Delegated Report (Members Briefing)		Analysis sheet		Expiry Date: 17/02/2022	
		N/A / attached		Consultation Expiry Date: 06/03/2022	
Officer			Application Number(s)		
Josh Lawlor			2021/6266/P		
Application Address			Drawing Numbers		
33 Hampstead Lane London N6 4RT			See draft decision notice		
PO 3/4	Area Team Signature	C&UD	Authorised Officer Signature		
Proposal(s)					
Demolition of existing garage and erection of a single storey plus basement dwellinghouse with front lightwell, rear sunken garden and associated alterations, including new boundary wall with gate.					
Recommendation:		Refuse planning permission			
Application Type:		Full Planning Permission			
Conditions or Reasons for Refusal:		Refer to Draft Decision Notice			
Informatives:					
Consultations					
Summary of consultation:		Site notices were displayed near to the site on the 09/02/2022 (expiring 05/03/2022)  The application was also publicised in the local press from 10/02/2022 (expiry 11/02/2022)

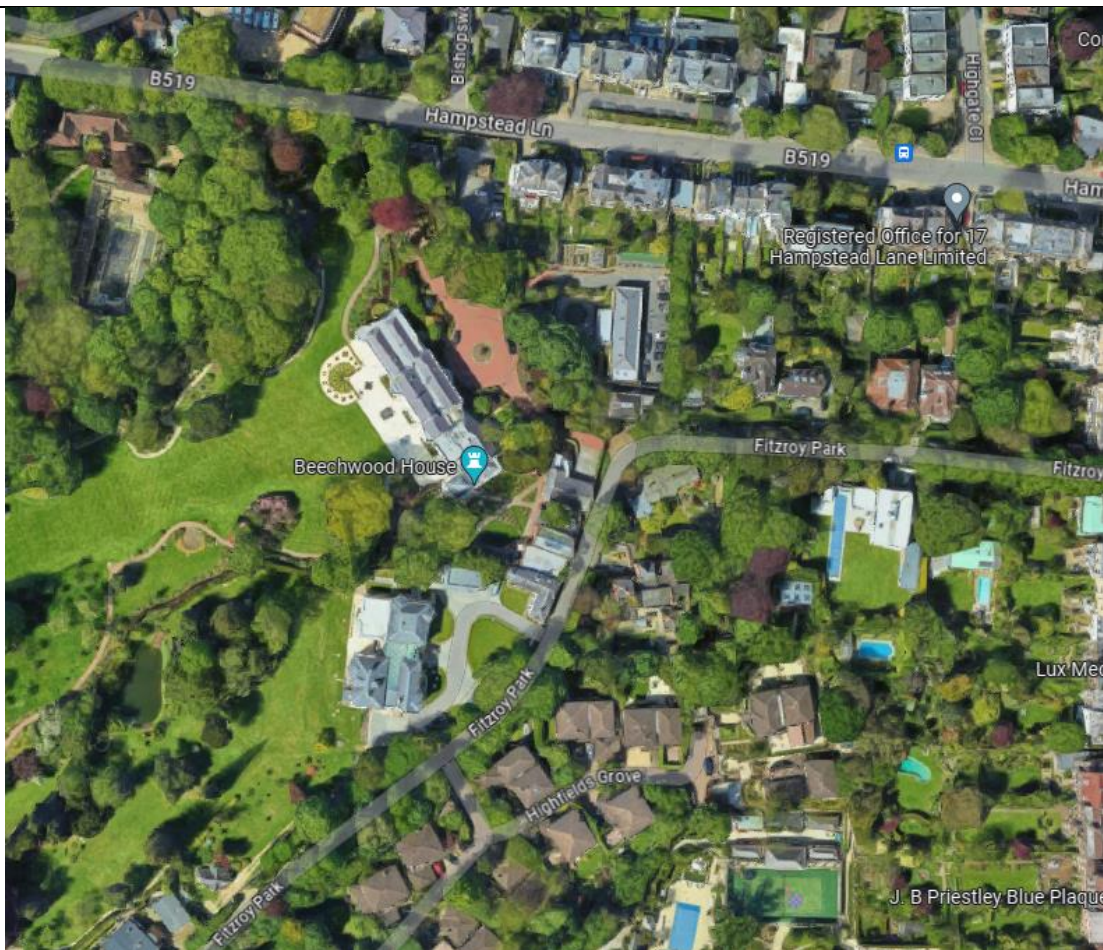
8.2. Secure, accessible (step-free), and covered cycle parking should be provided in accordance with Policy T1, the cycle facilities section of CPG Transport, and the London Plan. The London Plan standards are shown below. The proposed upper ground floor plan indicates that a bike shed would be provided for two cycles in the shared courtyard entrance area. This is acceptable and would have been secured by condition if planning permission were granted.
